Access Compliance Report

Public Rights-of-Way

(Curb Ramps)

Intersection ID: 2591	Main Street: BEARDSLEY_DR	Cross Street: HARTFIELD_DOWNS_DR	Location: SW
ADA ID: 80D5A0043A88	Ramp Type: PerpDiag	Initial Pass/Fail: Fail	Overall Compliance: No
		Severity Score: 25

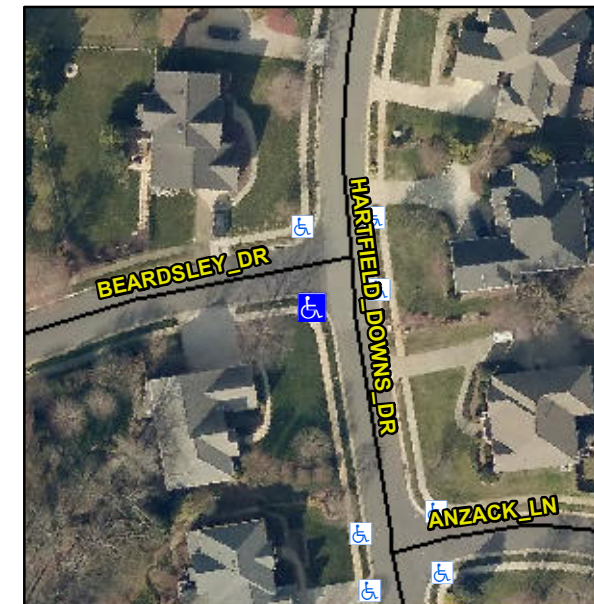
Not Found, R304.5.3

Compliance	Description	Data	Compliance	Description	Data
N/A	Ramp Length (in)	47.0	Yes	Ramp Slope (%)	5.4
Yes	Ramp Width (in)	48.0	No	Ramp XSlope (%)	9.0
N/A	Flare Type LT	N/A	N/A	Flare Type RT	N/A
N/A	Flare Slope LT (%)	N/A	N/A	Flare Slope RT (%)	N/A
N/A	Flare Traversable LT?	N/A	N/A	Flare Traversable RT?	N/A
N/A	Landing Length (in)	N/A	N/A	DWS Provided?	N/A
N/A	Landing Width (in)	N/A	N/A	DWS Contrast?	N/A
N/A	Landing Slope (%)	N/A	N/A	DWS Length (in)	N/A
N/A	Landing X Slope (%)	N/A	N/A	DWS Full Width?	N/A
N/A	Landing Curb? (Y/N)	N/A	N/A	DWS Offset (in)	N/A
N/A	Shared Landing?	N/A			
N/A	Gutter Ponding?	N/A	N/A	Gutter Slope (%)	N/A
N/A	Gutter Lip Ht (in)	N/A	N/A	Gutter X Slope (%)	N/A
N/A	Painted X Walk1?	No	N/A	Painted X Walk2?	No
	X Walk 1 Direction	To E		X Walk 2 Direction	To N
N/A	X Walk 1 Width (in)	N/A	N/A	X Walk 2 Width (in)	N/A
	X Walk 1 Slope (%)	2.6		X Walk 2 Slope (%)	4.9
	X Walk 1 X Slope (%)	6.0		X Walk 2 X Slope (%)	2.5

Remove & Replace Curb Ramp With Two New Directional Ramps or Equivalent.
